Safety and Airspace Regulation Group

CAA DECISION LETTER

BRISTOL INTERNATIONAL AIRPORT (BIA) RNAV STARS

Enclosure:1. BIA RNAV STAR Chart - ADBOB 1A and - BAXUN 1A

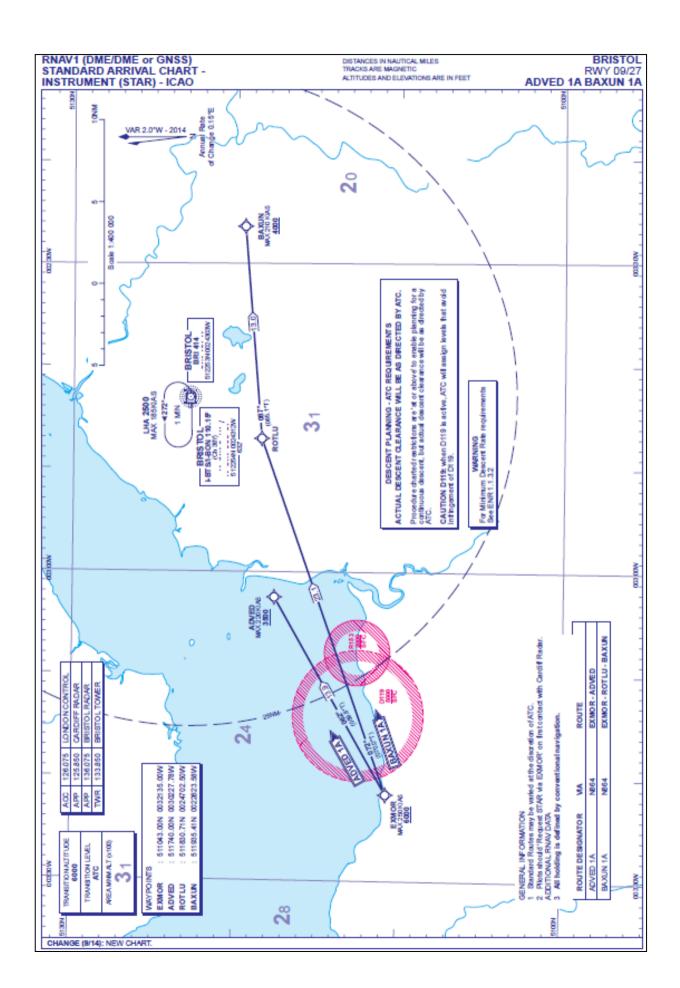
- 2.3 Procedure designs for the BIA RNAV STARs, identified as ADVED 1A and BAXUN 1A, are at Enclosures 1 and have been appropriately reviewed by CAA IFP staff. The procedures, which are ICAO compliant, have been successfully subjected to simulator trials. The associated ATS safety case has been considered and accepted by my Bristol Airport ATS inspector; it is worth noting that appropriate procedures are in place that will ensure that descent profiles and allocated levels take into account any notified EGD119 activation. There is no related CAS requirement or any proposed change in airspace classification associated with this ACP. All proposed procedures would be contained with existing CAS.

- 3.2.2 To mitigate a technical non-compliance with SARG Policy Statement Controlled Airspace Containment Policy (an element of the RWY27 procedure would route within 3 NM of the boundary of CAS), SARG has deemed that radar monitoring of the RWY27 procedure is essential. I assess that balancing the lack of requirement for additional CAS against the need for radar monitoring of the RWY27 procedure reflects a sensible risk based assessment of requirements.

- 4.3 The ERCD report on the environmental impact highlights that whilst the slight re-routeing of RWY09 traffic to offshore airspace would accrue some noise benefit; to date the sponsor has not been able to demonstrate the ACP expectation that the RNAV STARs would facilitate wider employment of CDAs, which would have an environmental benefit. To that end I will require BIA to facilitate CDAs to the maximum possible extent.

- 6.1 I am content that the proposed introduction of RNAV STARs catering for BIA arrivals departing the en-route environment at EXMOR is safe, which satisfies my primary statutory duty. Thereafter, when considering the competing demands of my remaining duties, together with the Directions and Guidance, I am satisfied that the introduction of the subject procedures is appropriate.
- 6.2 The STARs, to be identified as ADVED 1A and BAXUN 1A, will be formally established on 21 August 2014 at AIRAC 09/2014.
